**CONTRACT NO. DE-AC06-08RL14788 – TRANSMITTAL OF REVIEW OF THE 100K
INFRASTRUCTURE UTILITIES UPGRADE PROJECT SURVEILLANCE
S-11-EMD-PRC-001**

Surveillance Number: S-11-EMD-PRC-001

Title: Review of the 100K Infrastructure Utilities Upgrade Project

A-8004-835 (REV 0)

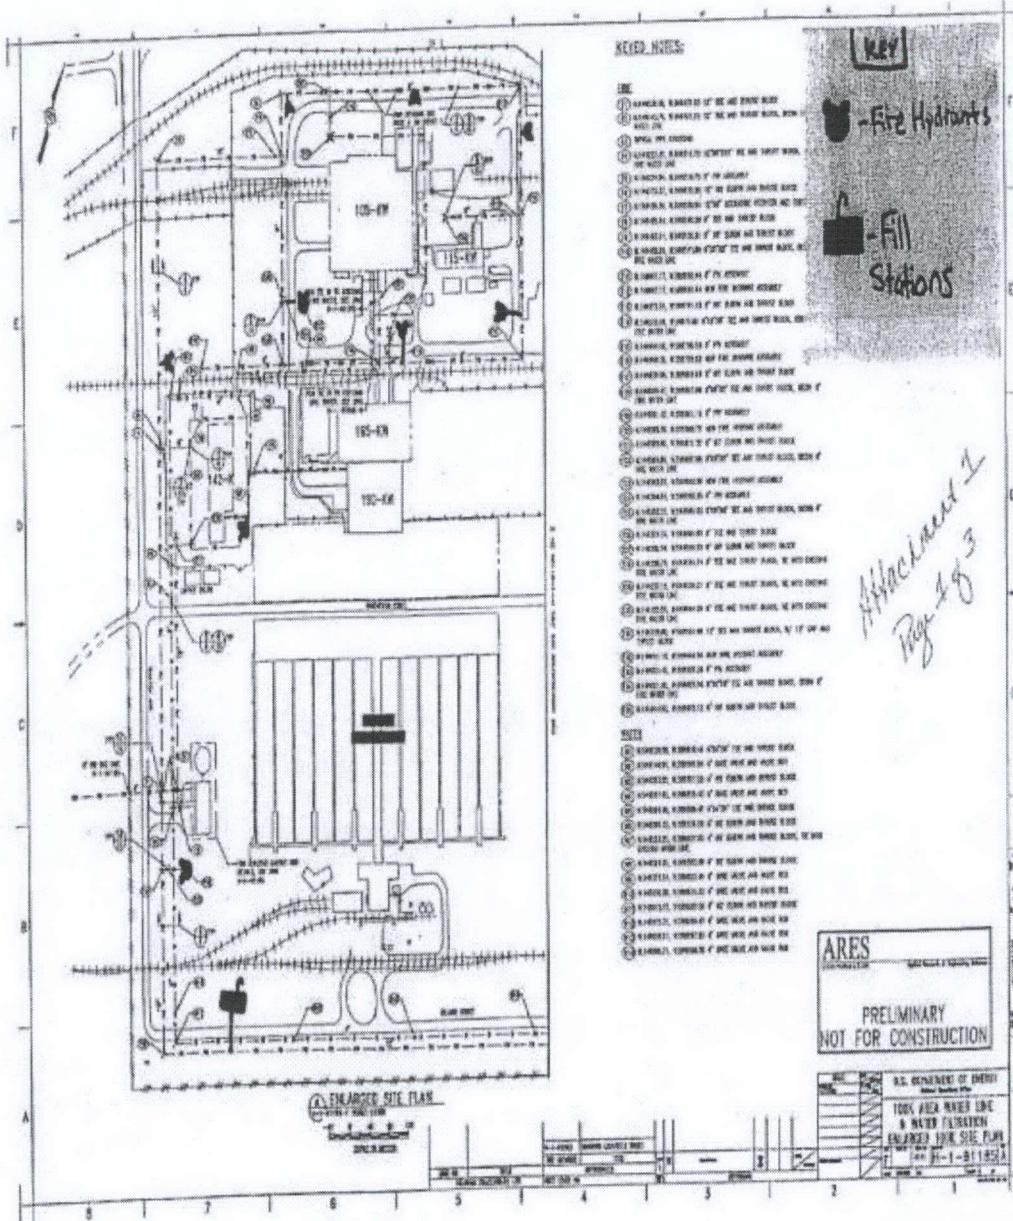
6	H-1-91185, Sheets 1 through 4: Please revise hydrant locations as shown on the attached drawing markup (Attachment 1).	Drawing markup shows hydrant locations as required by HFD and 100K.	Revise hydrant locations as shown. Please note that locations shown are approximate and are not based on survey information.	Y	Accept. (Conselman)	
7	H-1-91185, Sheet 4: This drawing still shows FW connection to Building 183KE.	This connection is not required for the new system.	Remove connection; show system cap point.	Y	Accept. (Conselman)	
8	H-1-91185, Sheet 9: PIV detail has been provided; PIV locations are not specified.		Provide PIV locations on system layout drawing and/or sections.	Y	Accept. (Conselman)	
9	H-1-91511, Sheet X: 1) Drawing does not call out fire resistance rating of interior wall. 2) Layout requires modification to accommodate service water pumps. 3) If exterior fire pump room double doors are replaced with a roll-up door, an additional man door will be needed.		Please revise drawing as appropriate.	Y	Accept. (Hagensen)
